STAFF REPORT

NEW BEDFORD HISTORICAL COMMISSION MEETING

September 12, 2016

LOCATION: 56-62 N Water Street (Map 53 Lot 175)

**SCHEME
#1**

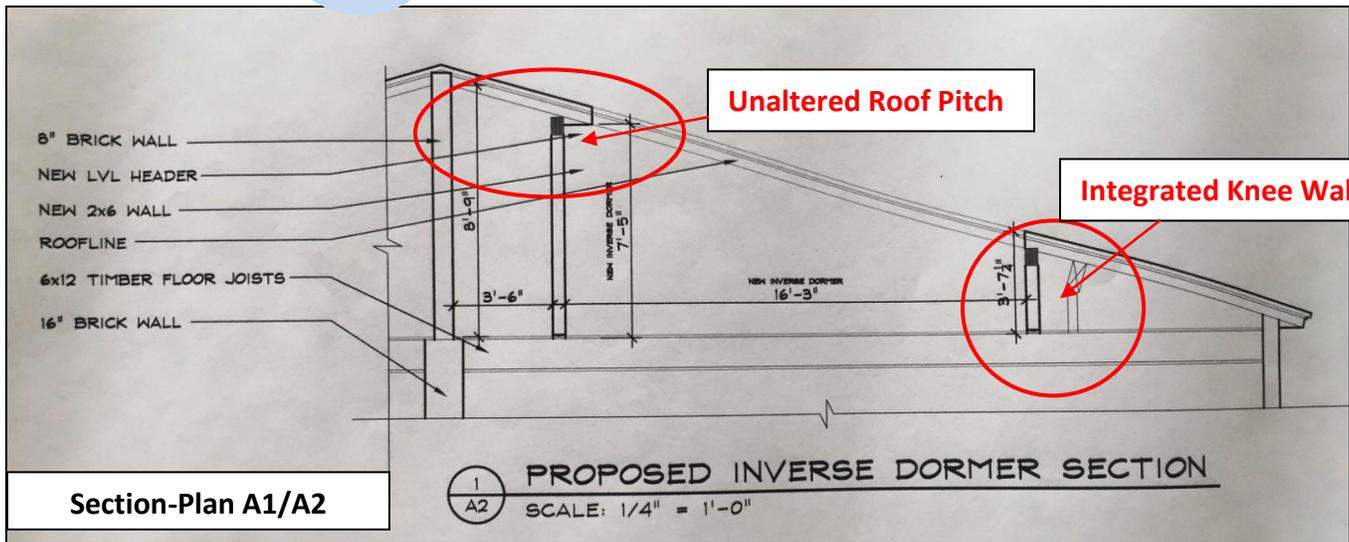
One plan (A1/A2) proposes a roof deck approximately 13' in width, 15' deep, with one set of French doors and no railing. The edge of the deck is set approximately 8' back from the roof edge and there is no alteration proposed to the building's roof pitch.

The design of the proposed roof deck as shown in Plan A1, allows the original roof line to remain intact, and due to its set-back from the roof edge, provides a knee wall to take the place of a railing.

SCHEME #2

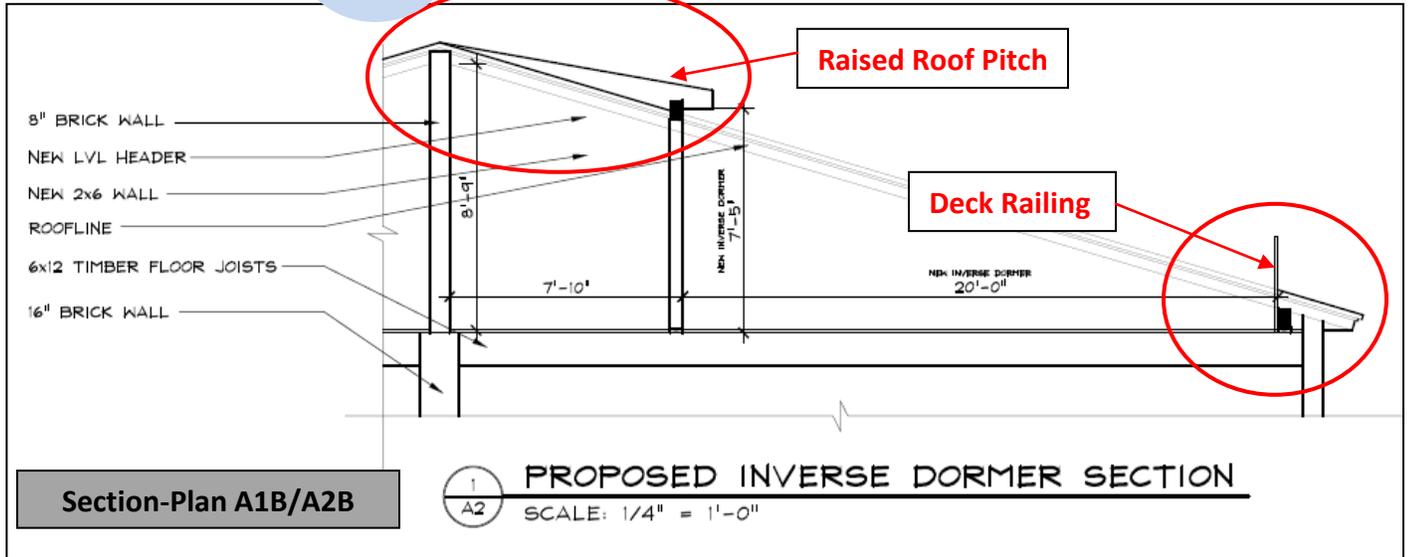
The second plan (A1B) proposes a roof deck measuring over 25' in width, 20' deep, with three sets of French doors and a railing situated at the roof's edge. This plan also proposes an alteration to the building's roof pitch.

The design of the proposed roof deck as shown in Plan A1B, alters the original roof line, and due to its depth and close proximity to the roof edge, requires the use of a railing.

A low pitch roof is an identifying characteristic feature of the early Greek Revival period. Staff believes raising the roof in order to accommodate the roof deck as proposed in Plan A1B to be inconsistent with the building's architecture. In addition to the pitch change, the proposed deck railing required in Plan A1B would significantly detract from the classical form of the building and its emphasized cornice line.

View Looking West from Front Street

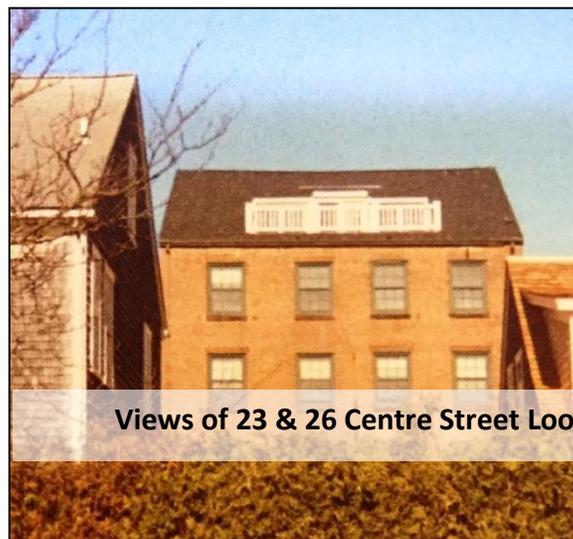
Due to the roof's low pitch and the density of the buildings within proximity of the subject building, there are limited public views of the proposed roof deck location, particularly if the deck opening is set back from the roof edge and there is no use of a railing.

Views of 23 & 26 Centre Street Looking North from Rose Alley

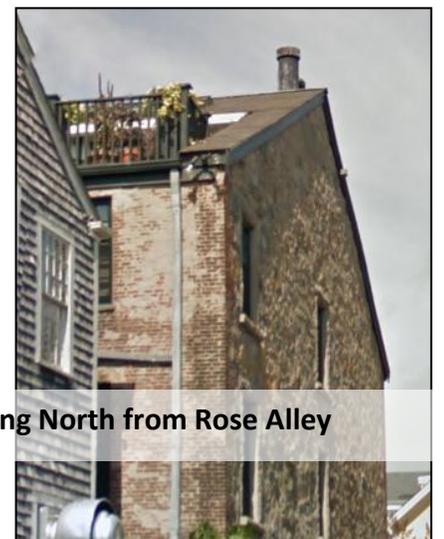
Several properties within the District do have roof decks with the use of railings close to the roof edge. However, the Commission may wish to note that these buildings do not hold the level of significance of the subject building.

STAFF RECOMMENDATION

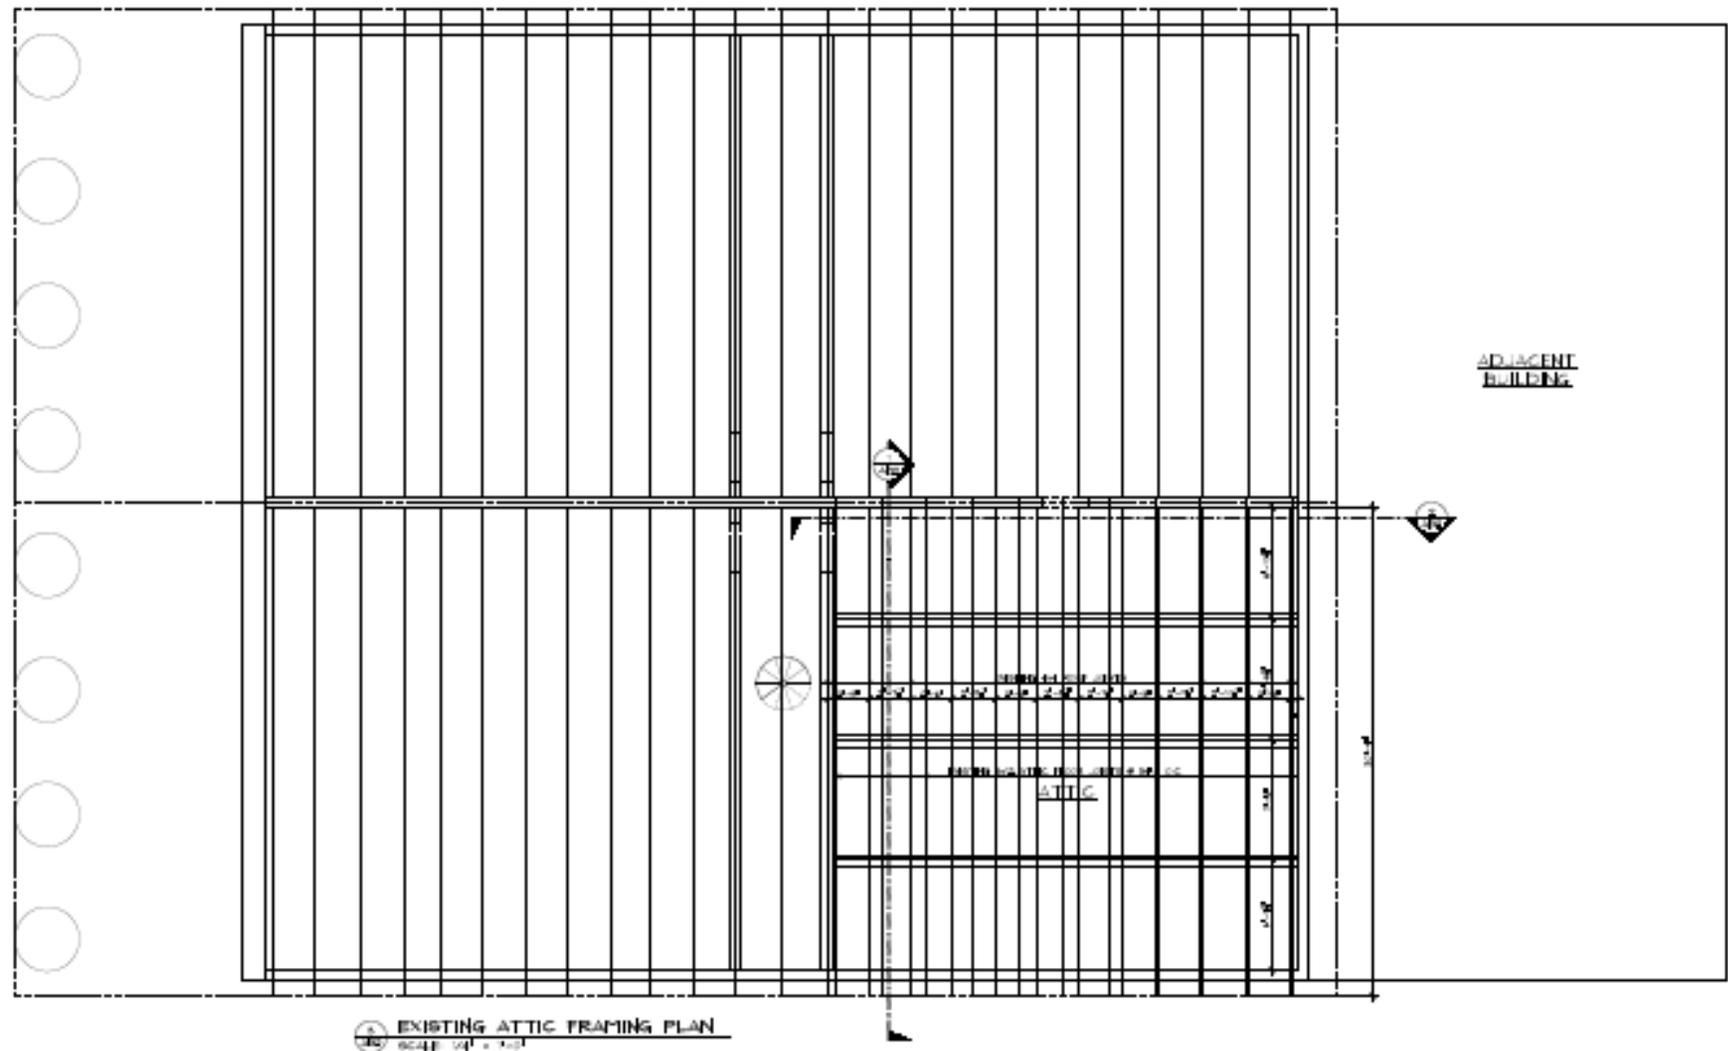
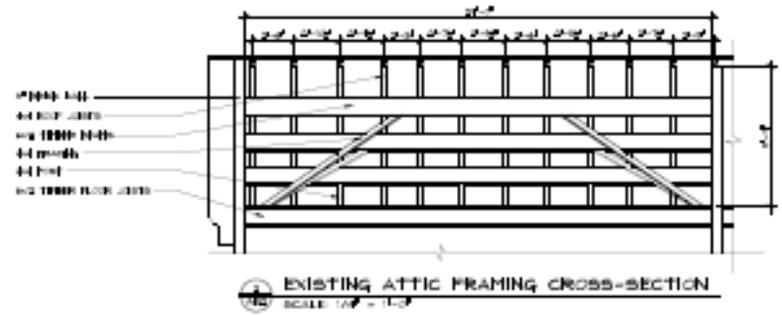
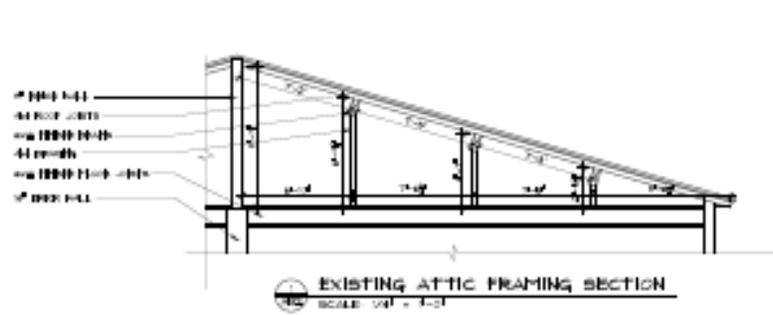
In reviewing the information accompanying both schemes submitted, staff recommends that the Commission give consideration to the type of roof deck depicted in these comments as “Scheme #1” in Plan A1/A2 over the alternate Scheme #2. The first scheme’s design does not alter the roof pitch, it sets back from the roof edge and does not utilize a railing—all preferable alternatives to the other plan submitted.

That said, unfortunately the level of detail and information required to render an approval to this type of project within the District remains incomplete at this time. Because the submitted application only provides schematic designs, lacking certain dimensional measurements and without a schedule of materials or their specifications, the plans do not provide details regarding wall siding, trim, doors, gutter and downspouts, type of roof flashing, and lighting necessary for a complete review.

For these stated reasons staff recommends tabling the application to an agreed upon date with the applicant, advising the applicant to further pursue a more detailed plan using the type of roof deck depicted in Plan A1/A2.
